Compliance Inspection Report: September 2017

RM File No:	RM150184
Description of Activity:	Extraction of gravel, removal of indigenous vegetation and associated earthworks
Consent Holder:	GBC Winstone Aggregates
Inspection Dates:	<u>Site inspections;</u> 12/07/17 30/08/17

Project:	Otaki Quarry Extension	Document No.:	Mm 04		
To:	GBC Winstone	Date:	31 July 2017		
Attention:	Dan McGregor	Cross Reference:	Mm 02 r01 2015015W Mm 03 r01 2015015W		
Delivery:	Email	Project No.:	2015015W		
From:	Steve Arden	No. Pages:	4	Attachments:	No
Subject	Bund Amendments - Noise Effects

Project:	Otaki Quarry Extension	Document No.:	Mm 02 r01		
To:	GBC Winstone	Date:	30 June 2017		
Attention:	Dan McGregor	Project No.:	2015015W		
From:	Steve Arden	No. Pages:	2	Attachments:	No
Subject	Acoustic Modelling - Paper Road Comments

Figure 1: Noise Contours (Stage 1B) – Split Berm

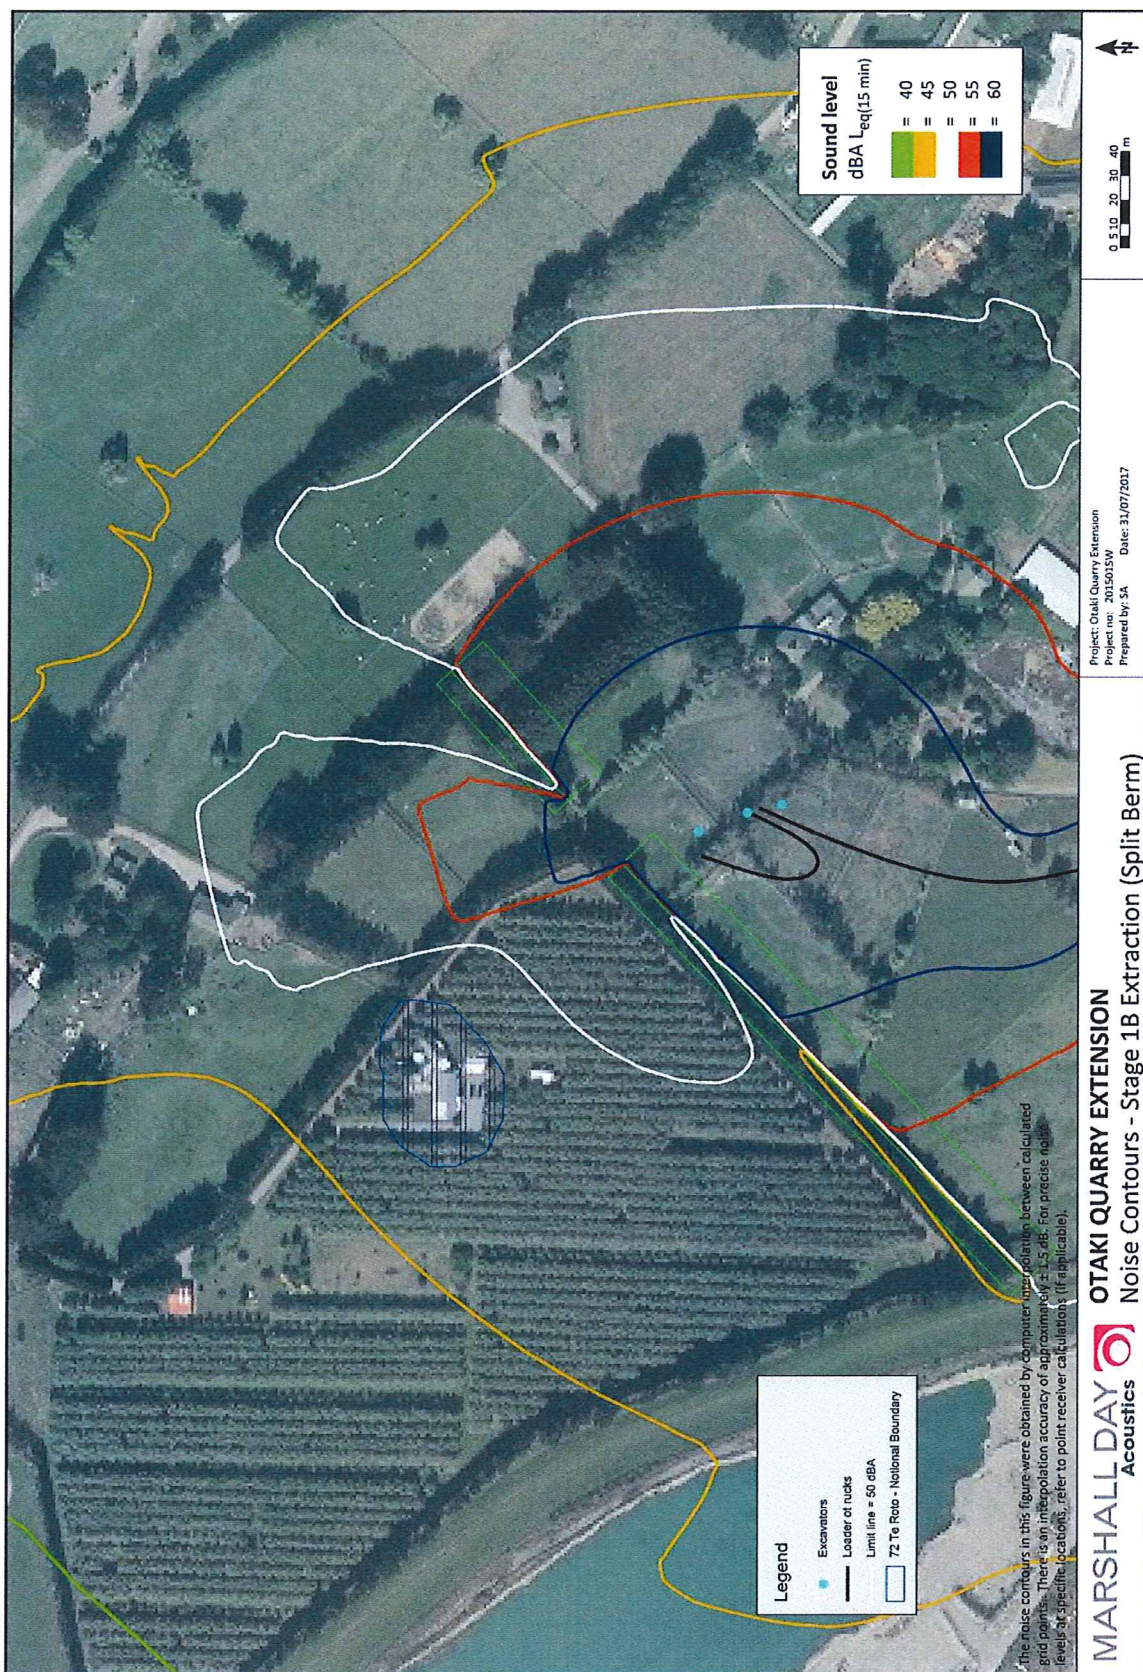
Council Request 4: *Figure 1 in the Memo (Mm 02 r01 2015015W) does not show the dwelling at 72 Te Roto Road nor the extent of the notional boundary around the dwelling.*

Council Request 5: *There is considerable uncertainty from the Memo as to how close to the paper road the quarrying can take place and still comply with 50dB LAeq:*

Council Request 6: *We recommend that MDA provides clarification of their claim that the quarrying operation can take place right up to the western edge of the paper road or whether a no-go area needs to be identified west of the paper road to allow greater confidence that the noise limit can be met:*

Our Response 2: The assessment location is anywhere within the notional boundary of any dwellings. In this case, the closest dwelling (and potentially exposed to highest noise levels) is 72 Te Roto Road. Noise levels were predicted for the western, southern and eastern notional boundaries of 72 Te Roto Road. To ensure these positions were representative of the notional boundary, a noise contour was produced to ensure that noise levels did not exceed the limit anywhere within the notional boundary of 72 Te Roto Road. This is shown in Figure 1.

Our Response 4: This is shown in Figure 1 overleaf, complete with noise contours.

Our Response 5 and 6: The modelling shows that quarrying up to the western edge of the paper road can occur, and noise levels are predicted to remain within the relevant limit. This can be seen in Figure 1. As stated in *Mm 02 r01 2015015W*, no quarrying should occur east of the paper road until the bund is complete or additional mitigation measures are included.

Figure 2: Noise Contours (Stage 3) – Shortened Bund

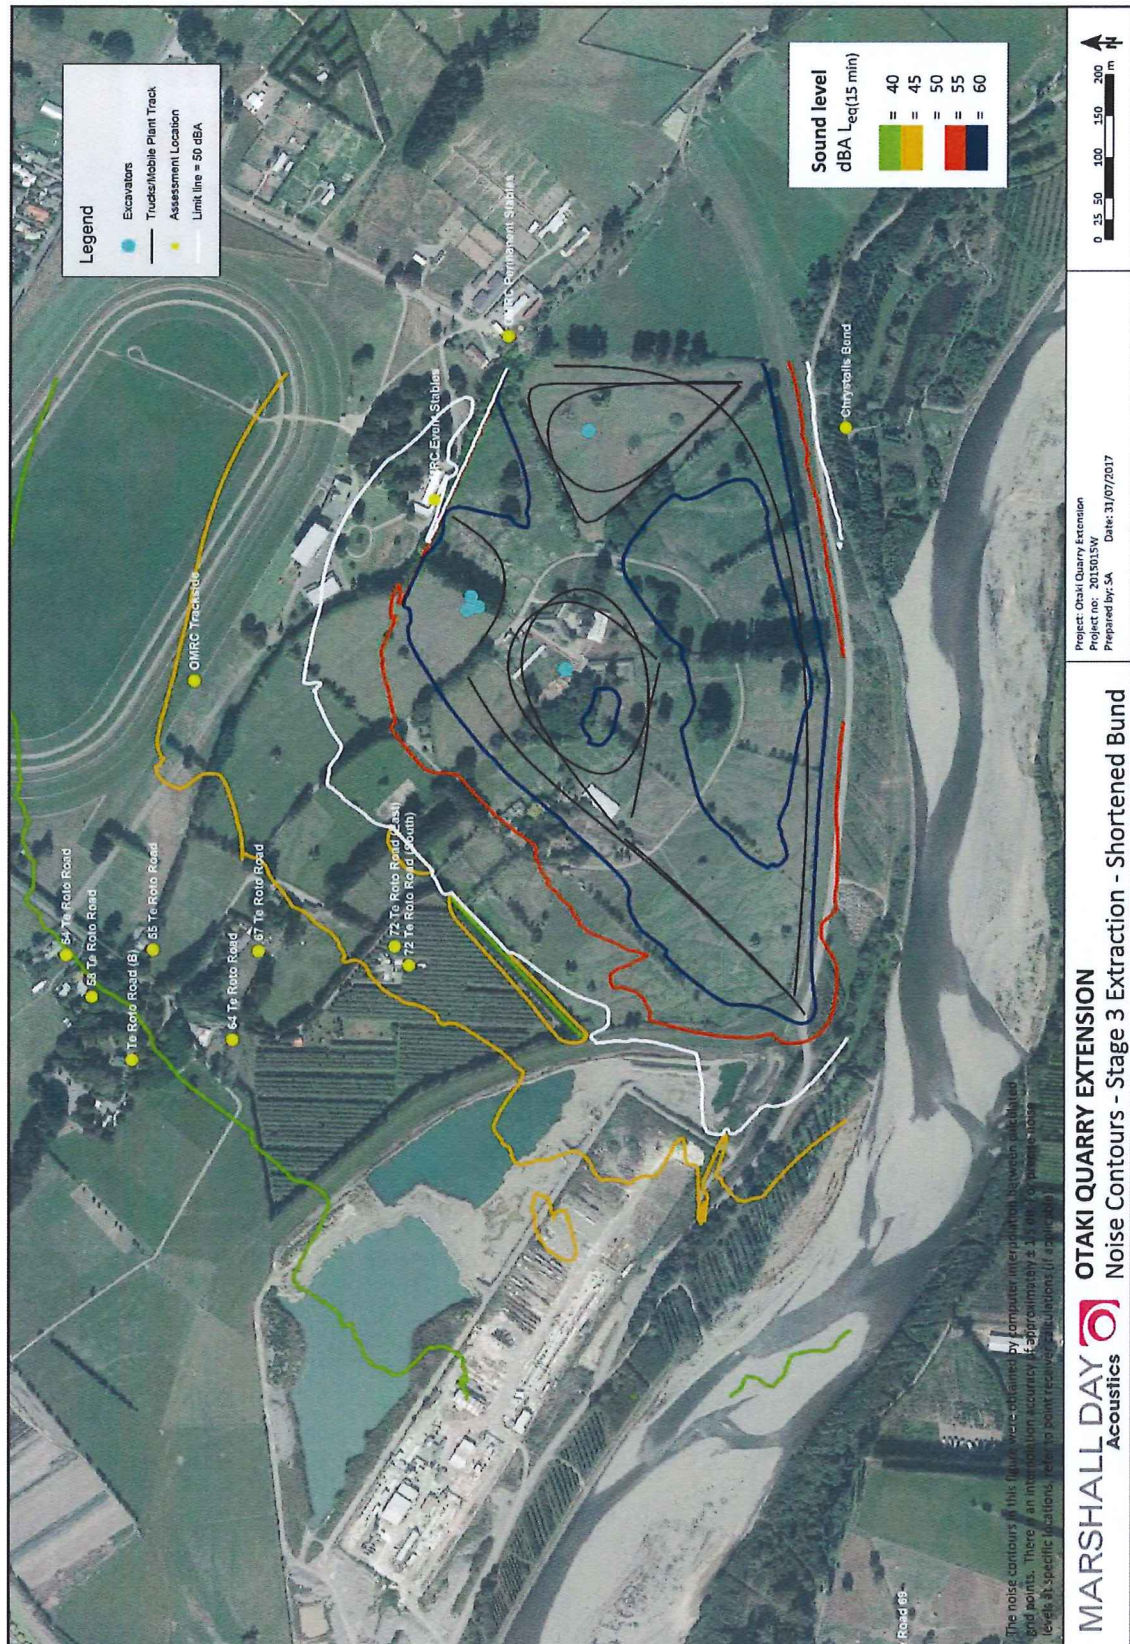
Although not requested by the Council, to provide greater certainty with regard to the predictions of noise levels due to shortening of the bund, we have included a noise contour showing the results of our prediction.

The noise predictions are shown as a noise contour included as Figure 2.

- Noise levels are predicted to comply with noise limits as stated within the conditions of consent when quarrying Stage 1B up to the western edge of the paper road.
- Quarrying within Stage 1B should not occur east of the paper road until additional mitigation is implemented (i.e. completion of the bund).
- Noise levels are predicted to comply with the noise limits as stated within the conditions of consent with a shortened bund (up to Stage 3).
- The bund should be completed as designed prior to quarrying of Stage 4. However, site preparation for Stage 4 is allowable.

Figure 1: Aerial showing break in bund due to paper road. Paper road follows parallel red lines.

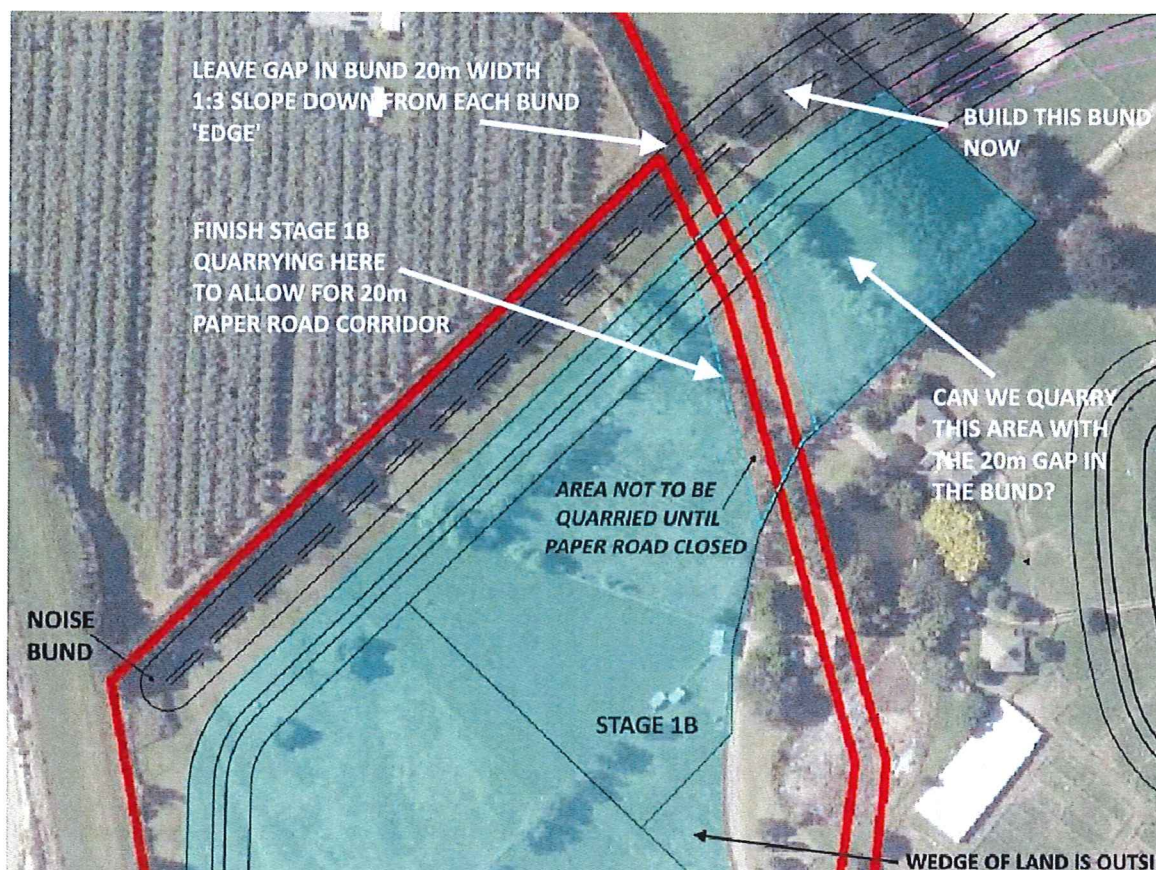
1. Where the source of the quarrying is assumed to be,
2. Where the receiver is assumed to be, and
3. The extent of the bund and the slope at the edge.

Figure 1 in the Memo does not show the dwelling at 72 Te Roto Road nor the extent of the notional boundary around the dwelling. The notional boundary also extends to the side of the dwelling for a distance of 20 metres. From what we can see this means that the notional boundary would overlap the eastern/northern boundary of the site at the closest point to the dwelling.

I consider that this further information now clarifies the concerns expressed in Acousafe's email dated 24 July 2017. The reasoning and the predictions set out in the memorandum support the conclusions that are reached. The predictions are that the quarrying can take place to the west of, and up to, the paper road as long as the bund is constructed as assumed in Figure 1 of the report i.e. with the gap where the paper road exists.
